Architectural Review
and Historic Preservation Board
Agenda Report

File : AR 17-16

RE: Bill's Towne Lounge – Downtown Storefront Remodel at 135 Main Street

EXTERIOR ELEVATION (MAIN STREET) - AS BUILT / DEMOLITION
SCALE: 1/4"=1'-0"

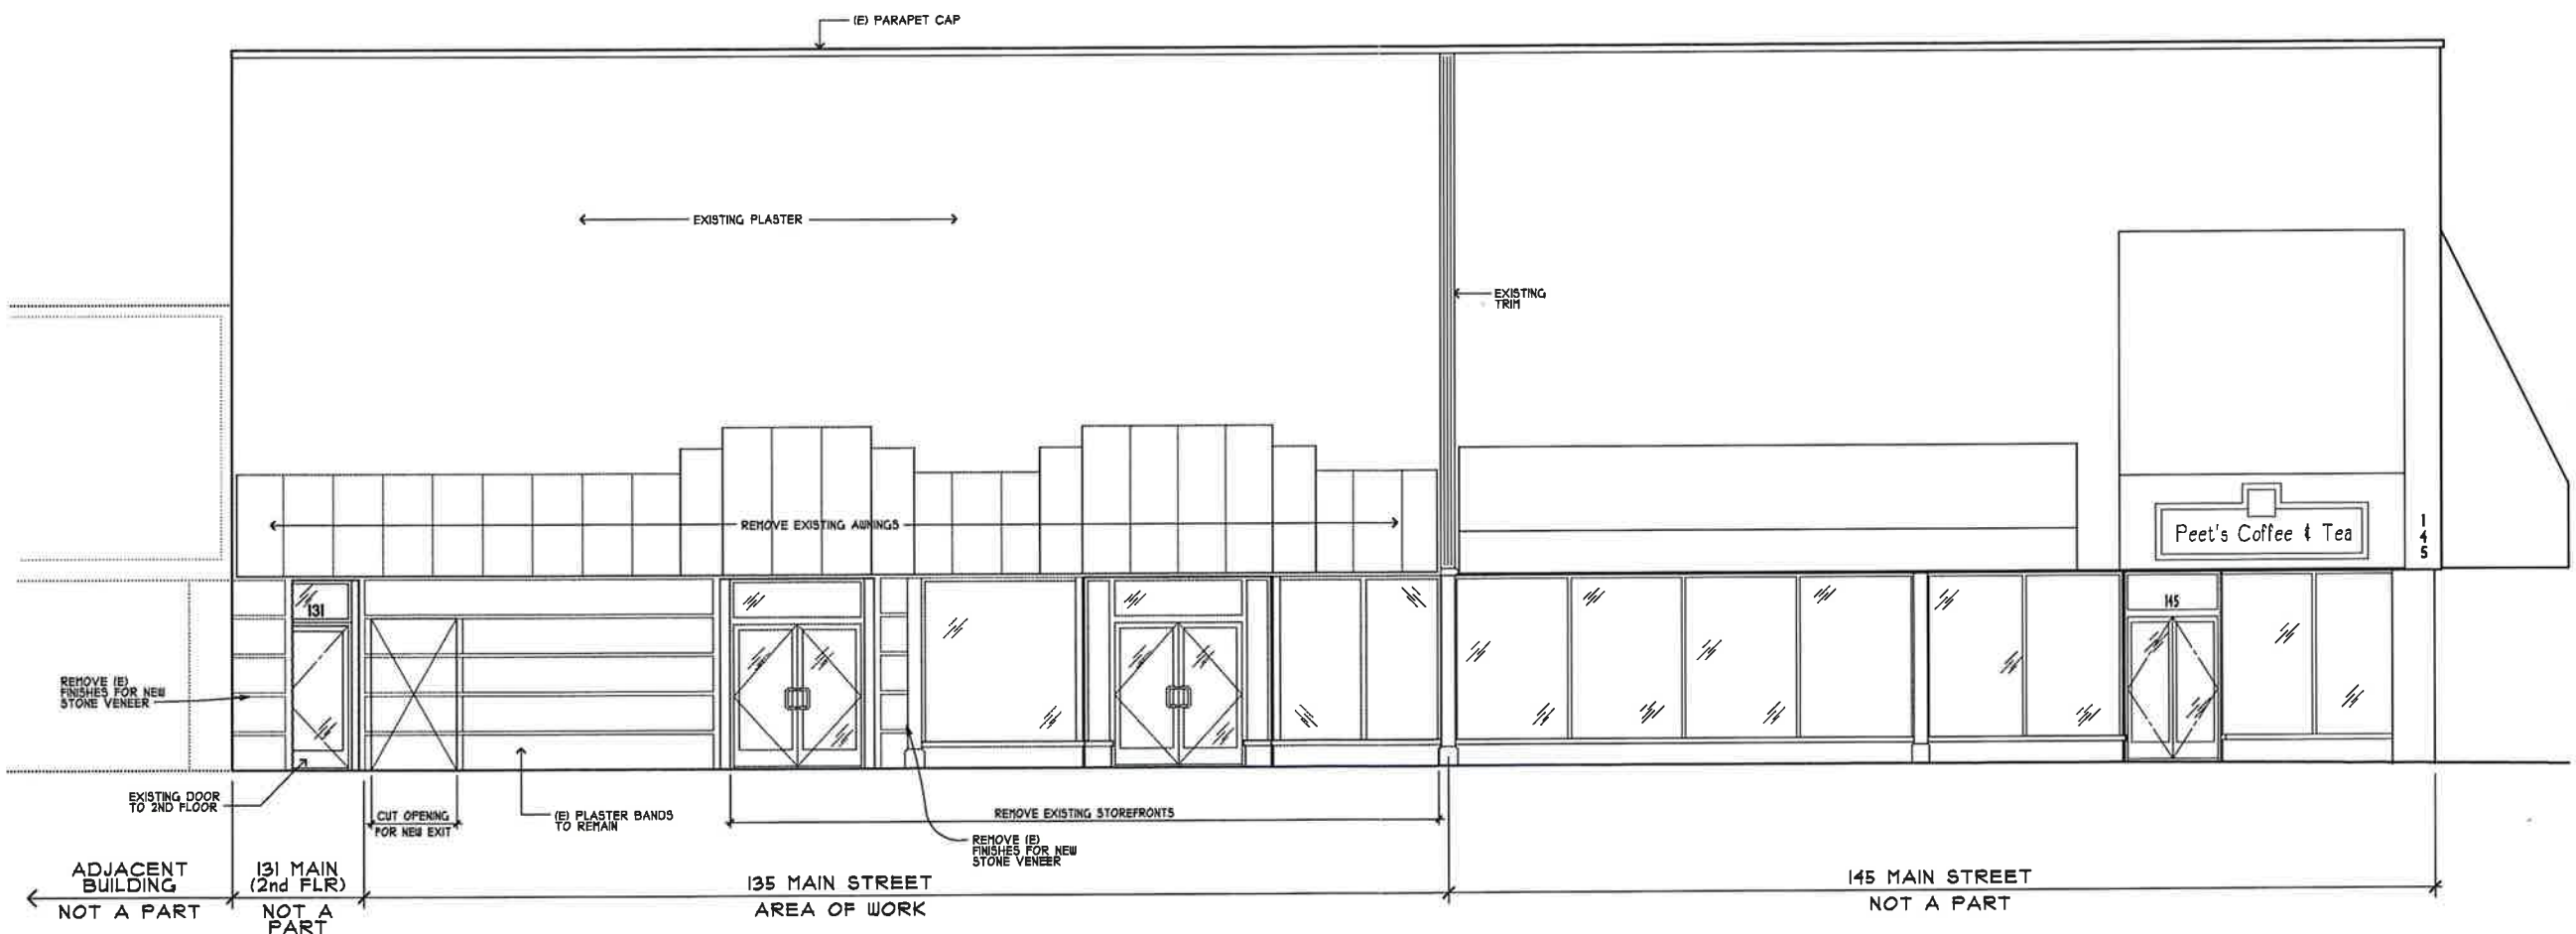
From building file records, the current storefront appears to have been structurally remodeled in the early 1980s, followed by addition of canvas awnings in 1986 (see Existing Elevation, **Attachment D**). The two murals were painted on the exterior during the tenancy of a music store use (*Main Street Music*) sometime after 1991. The existing façade does not include any historically significant elements.

EXTERIOR ELEVATION (MAIN STREET) - FACADE REMODEL
SCALE: 1/4" = 1'-0"

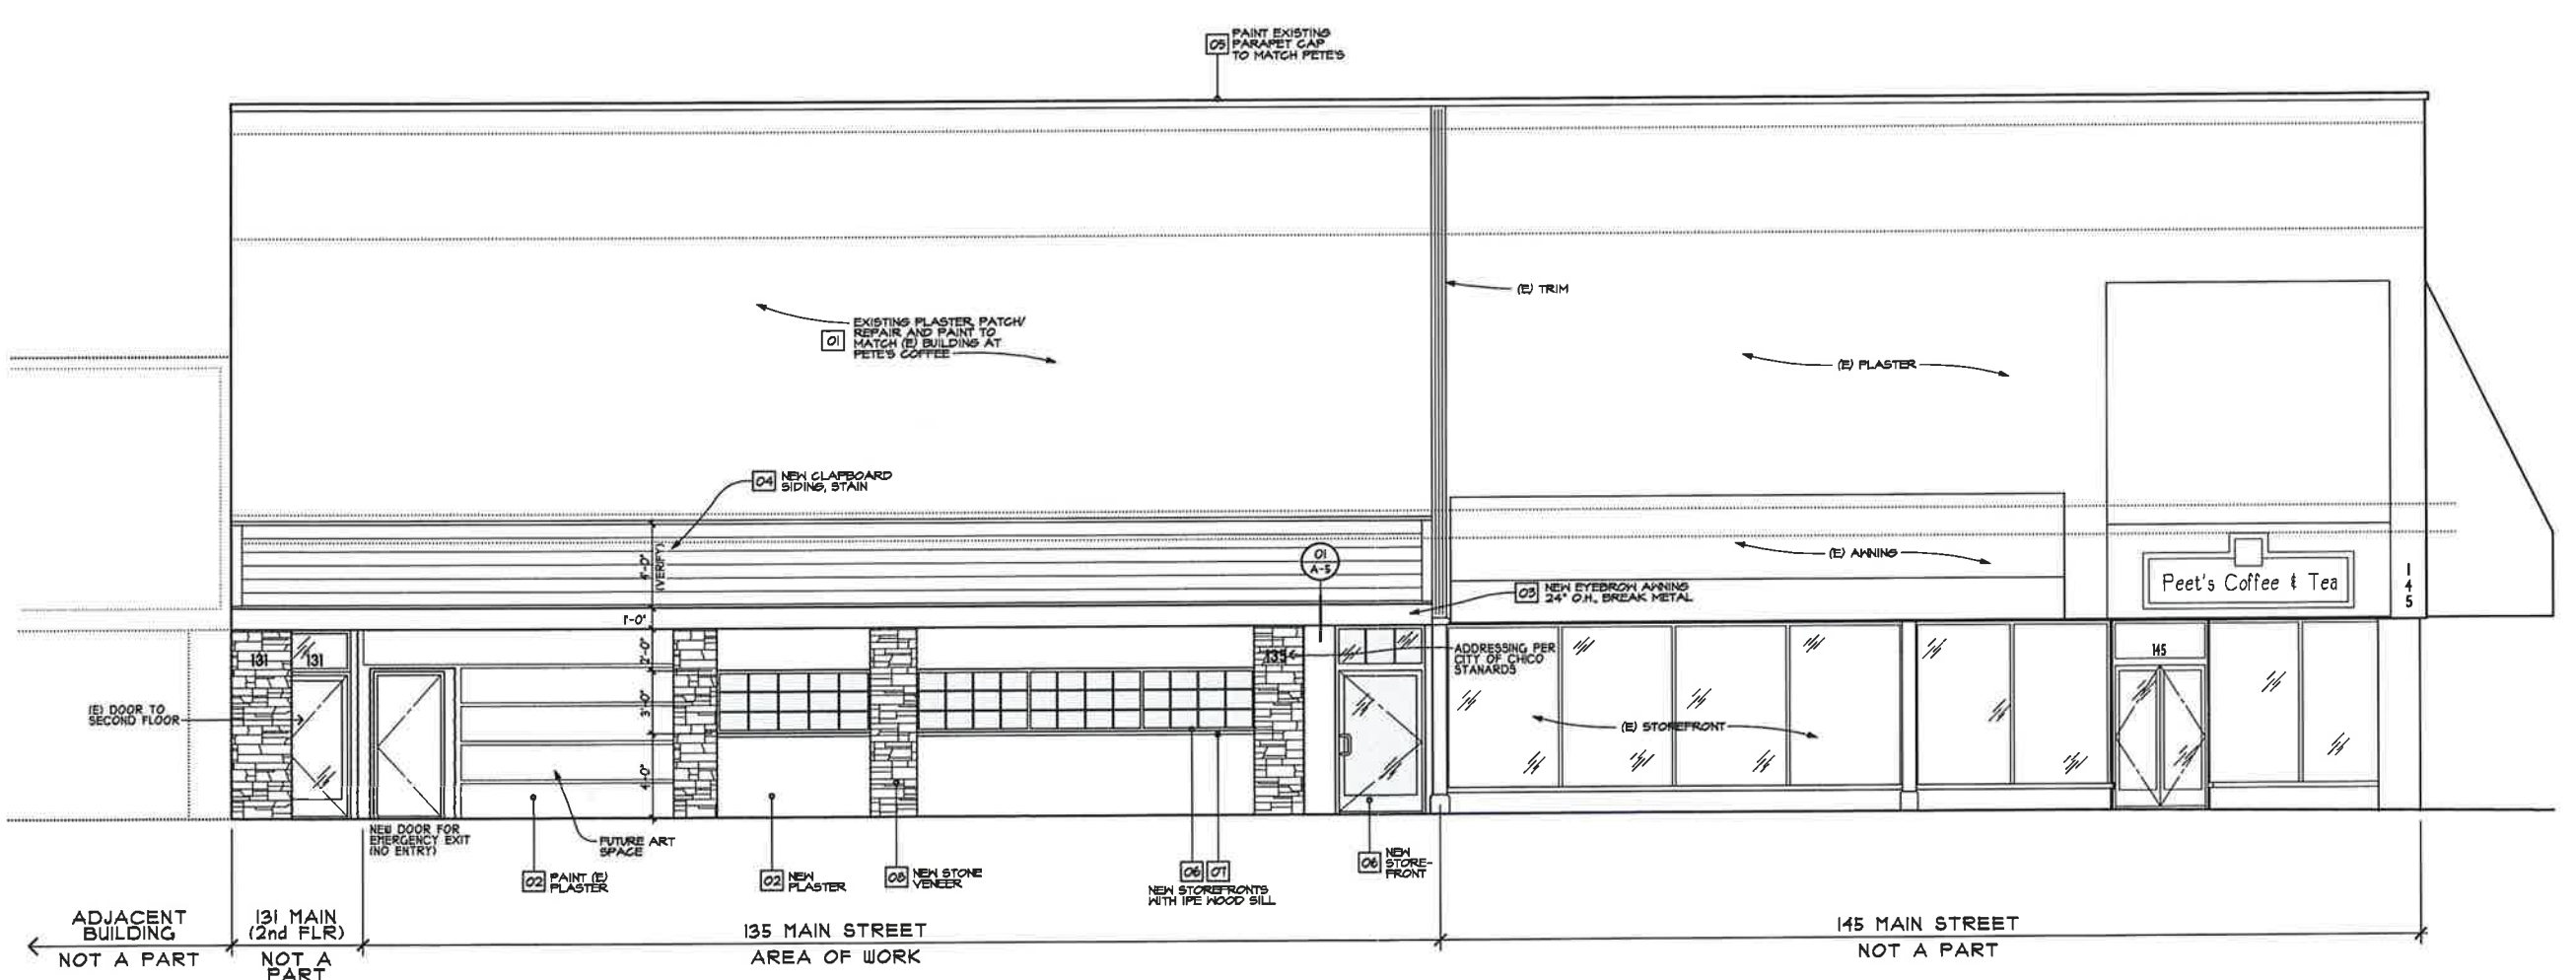
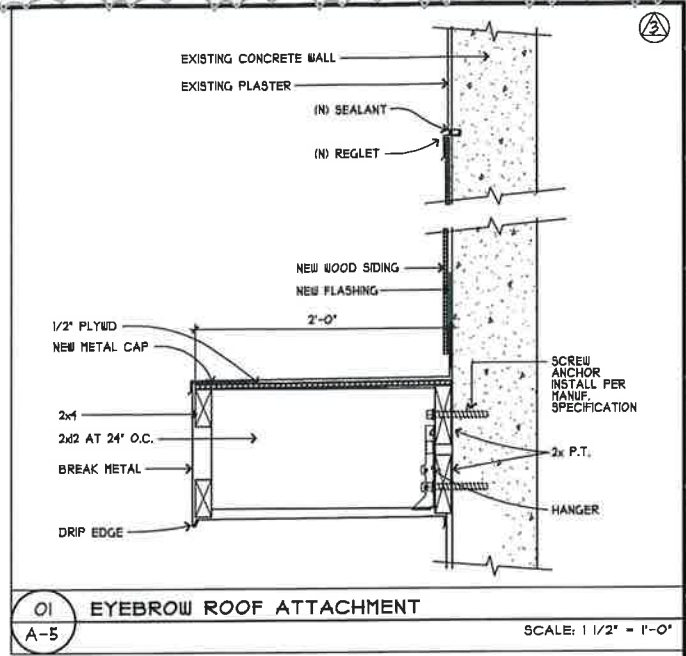
The proposed remodel calls for painting the upper-half of the façade grayish-beige with brown parapet cap to match the neighboring building occupied by *Peet's Coffee* (see Proposed Elevation, **Attachment E**, and Colors/Materials **Attachment F**). A band of wooden clapboard siding, four feet in height, would be added to the space formerly occupied by fabric awnings. The siding would be stained to retain its natural wood-grain appearance. A flat "eyebrow" awning would be constructed at the base of the clapboard and would extend from the building approximately 2 feet.

At the ground-floor level, two existing double-door storefront assemblies would be replaced with a single large storefront door and elevated windows with grid dividers located four- to seven-feet above sidewalk grade. Transom windows are proposed above the new entry door. The main field color at the ground level would be black, broken up by dark ledge-stone pilasters. A portion of the wall currently occupied by the Beatles mural would be demolished

to install a required fire exit, though the remainder of the space would be reserved for future artwork. Recessed down-lighting would be included within the new awning.

The proposal offers an updated architectural image for the 30-plus year old façade that has seen upgrades on either side in the past 15 years (most-recently Dolce Homes in 2013). The design uses horizontal elements just above the pedestrian level that complement adjacent building designs and diminish the perceived height of the building. Stone pilasters at the ground level suggest a strong supporting base, communicating stability for passersby. Adding transom windows above the new entry door and the wood-stained siding reflect historic elements of Downtown architecture. Staff supports the proposal.

1. All approved building plans and permits shall note on the cover sheet that the project shall comply with AR 17-16 (Bill's Towne Lounge). The approval documents for this project are date stamped Apr 27, 2017.
2. All wall-mounted utilities and roof or wall penetrations, including vent stacks, utility boxes, exhaust vents, gas meters and similar equipment, shall be screened by appropriate materials and colors. Adequate screening shall be verified by Planning staff prior to issuance of a certificate of occupancy.
3. Future signage for ground-floor uses shall be limited to the area on or below the clapboard siding, and shall not include plastic-faced backlit cabinet signs.
